**Board of Zoning Appeals Meeting  
July 15, 2025**

<b>CASE NUMBER:</b>	<b>V-25-0004</b>
<b>PROPERTY LOCATION:</b>	<b>1425 Spyglass Hill Drive, Johns Creek, GA 30097</b>
<b>CURRENT ZONING:</b>	<b>CUP (Community Unit Plan) Conditional</b>
<b>PARCEL SIZE:</b>	<b>0.72 Acres</b>
<b>PROPERTY OWNER:</b>	<b>Faysal Kapadia</b>
<b>VARIANCE REQUEST:</b>	<b>Encroachment into the 75-foot stream buffer to construct a single-family detached home</b>
<b>STAFF RECOMMENDATION:</b>	<b>APPROVAL WITH CONDITIONS</b>

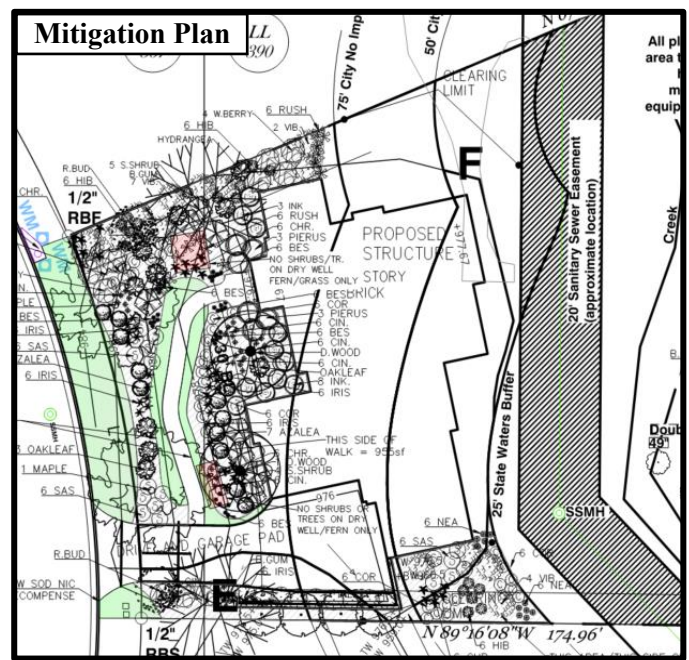
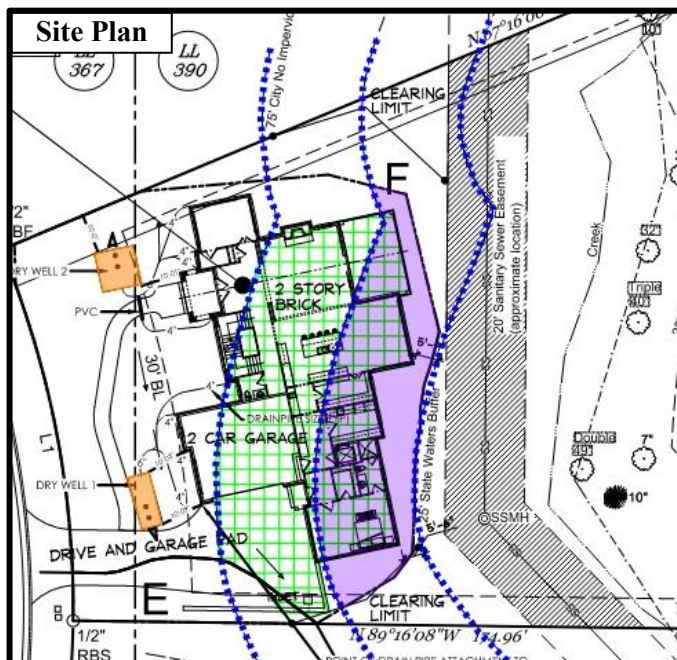
The Applicant is requesting to encroach 50 feet into the 75-foot stream buffer to construct a single-family home. The proposed improvements will result in 2,083 square feet of disturbance in the 50-foot undisturbed buffer (shown in purple) and 3,642 square feet of impervious surface in the 75-foot stream buffer (shown in green hatch). The Applicant has not proposed any land disturbance within the State's 25-foot stream buffer.

To offset the stormwater and environmental impacts associated with the proposed stream buffer encroachment, the Applicant proposes to install two drywells (shown in orange on the site plan) intended to retain the first one inch of stormwater runoff associated with the proposed 3,642 square feet of impervious surface. In addition, the Applicant proposes to plant 7 large trees, 13 small trees, 81 shrubs, and 318 groundcover plants to provide a total of 5,268 square feet of planted area to mitigate the total proposed disturbance within the stream buffer.

The subject property was platted in Fulton County in 1991, which showed a 100-year floodplain bisecting the property north to south, but the existing Chattahoochee River tributary was not shown at the time. With the incorporation of the City, the stream buffer was expanded to 50 feet with an additional 25-foot impervious surface setback on both sides of the stream. The expansion of the stream buffer has created hardship for the homeowner, as the buffer encompasses nearly 84% of the property, leaving approximately 1,775 square feet of buildable area outside of the stream buffer. Staff is of the opinion that the requested variance is necessary to build a residential dwelling consistent in form and building size of existing homes within the development.

Based upon the findings and conclusions herein, staff recommends **APPROVAL** of V-25-0004, subject to the following conditions:

- 1) The proposed development shall not exceed the following encroachments, as shown on the site plan received by the Community Development Department and date stamped on May 12, 2025:

- a. 50 linear feet of encroachment into the stream buffer.
  - b. 3,642 square feet of impervious surface within the 75-foot stream buffer.
  - c. 2,083 square feet of disturbance within the 50-foot undisturbed buffer.

- 2) The applicant shall install drywells that retain the first one inch of stormwater runoff for the 3,642 square feet of impervious surface in the 75-foot stream buffer as shown on the site plan received by the Community Development Department and date stamped on May 12, 2025. The drywell location and design shall be approved by the City's Land Development Manager prior to the issuance of a building permit, and the drywell shall pass City inspection prior to the issuance of a Certificate of Occupancy for the home.

- 3) A vegetative planting plan shall be submitted to the Community Development Department, as part of the Building Permit application. Said plan shall be consistent with the mitigation plan received by the Community Development Department on May 12, 2025. The final vegetative planting shall pass City inspection prior to the issuance of a Certificate of Occupancy for the home.
